# Original Roof Planning Drawing

## Facade Material Change

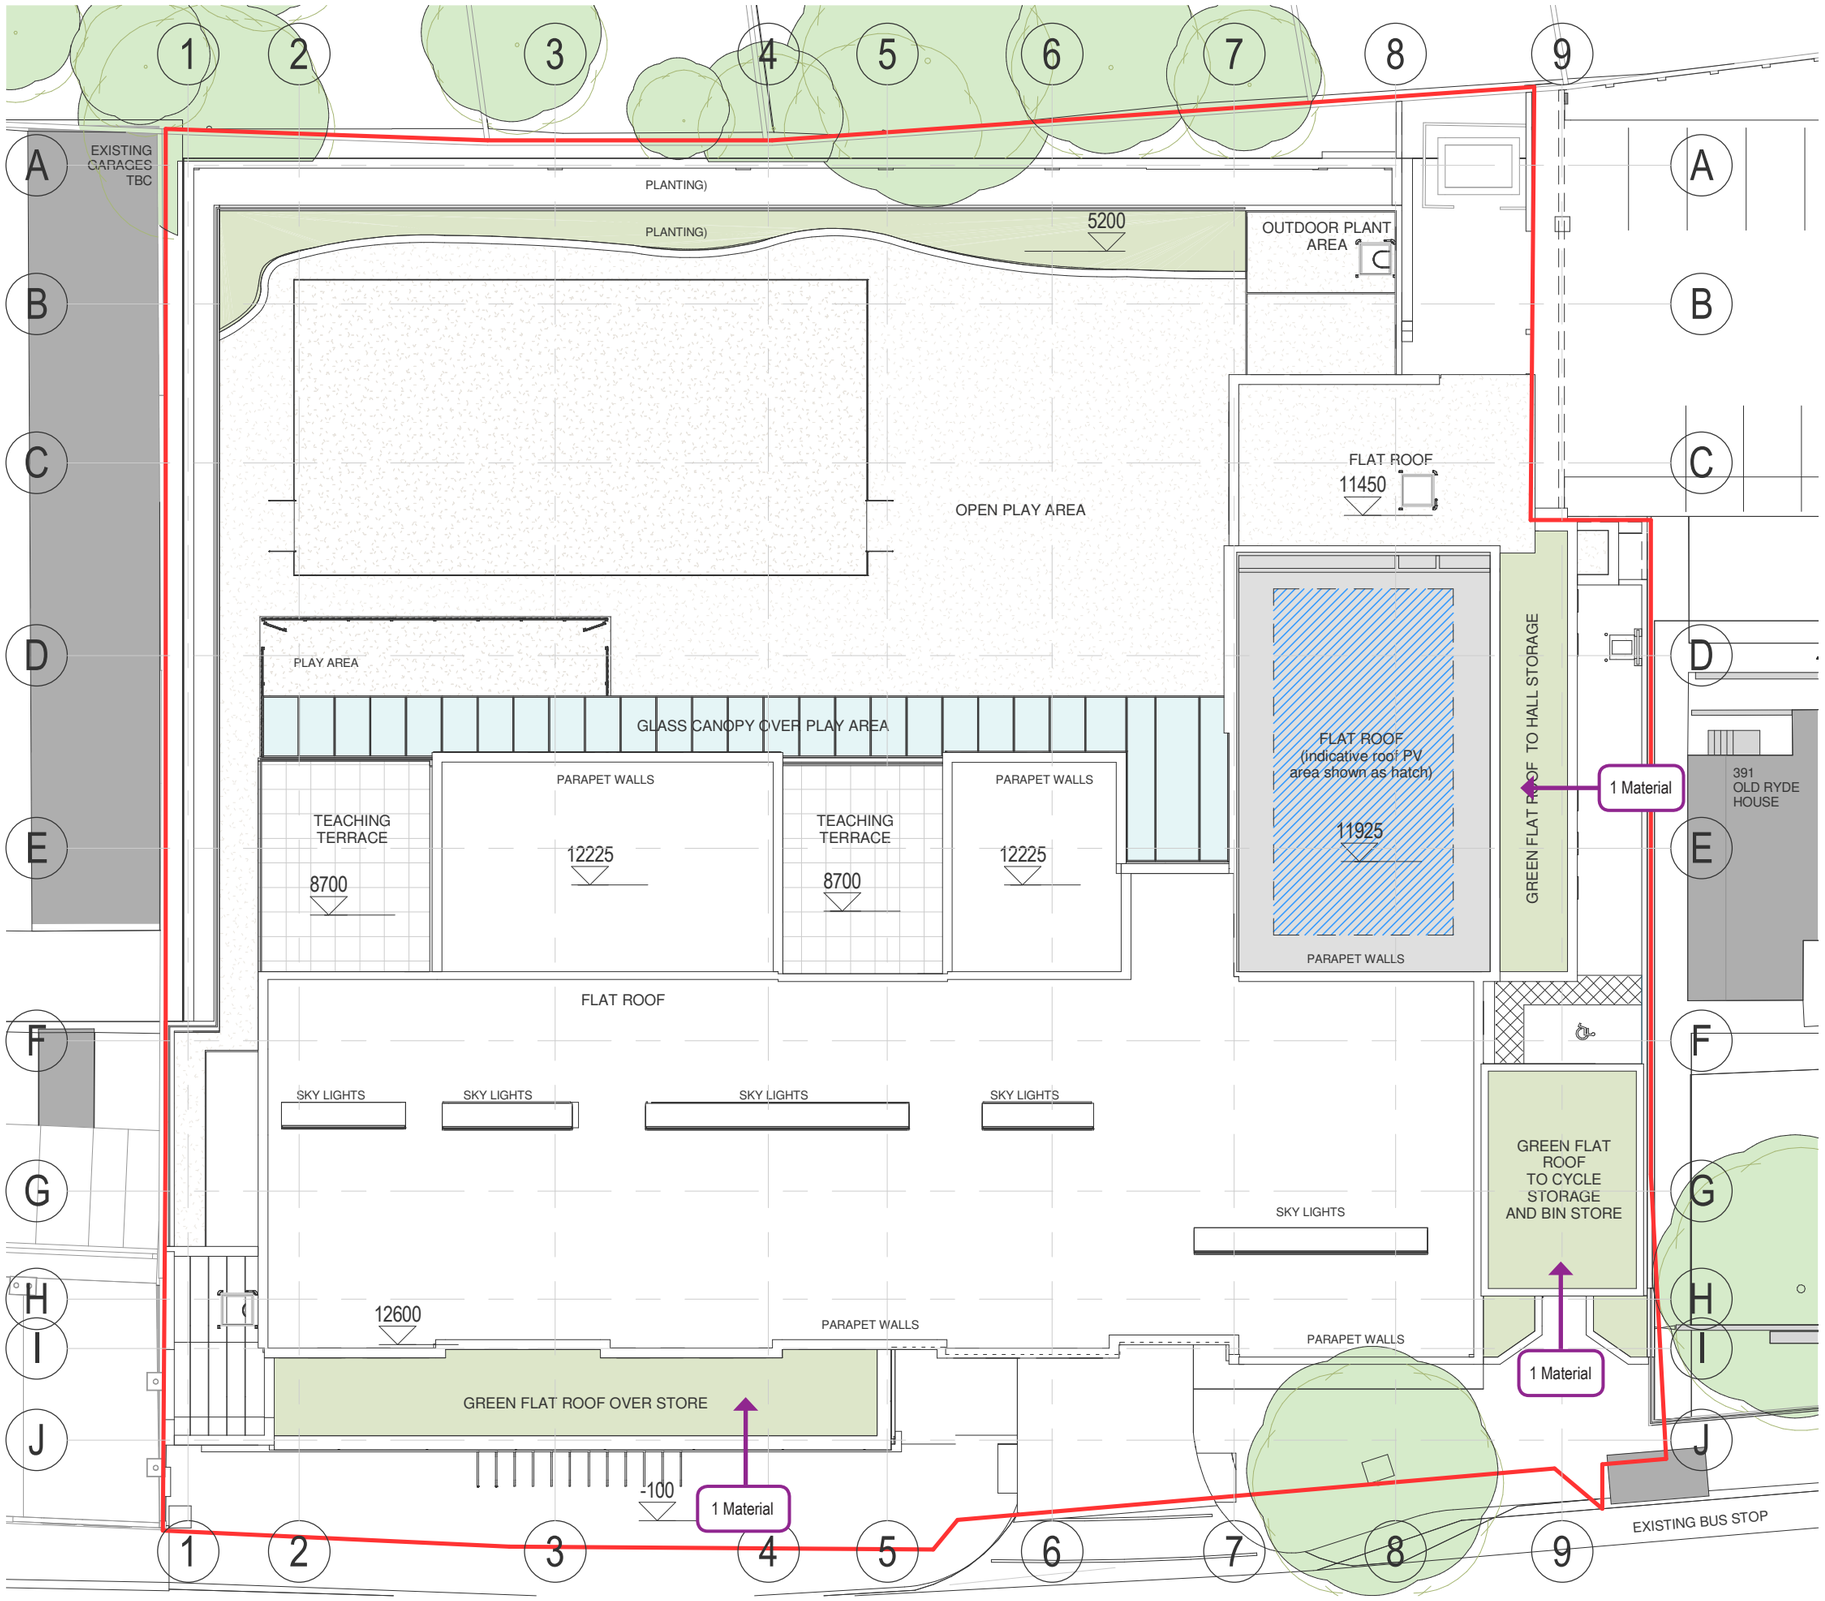
1 Proposed Change: Green roof position moved to main roof level.

2 Proposed Change: Guardrail and man-safe design incorporated.

Reasons: Green roofs combined on top floor for improved maintenance access.

Reasons: Guard rail and man-safe system required to satisfy current Health and Safety statutory regulations.
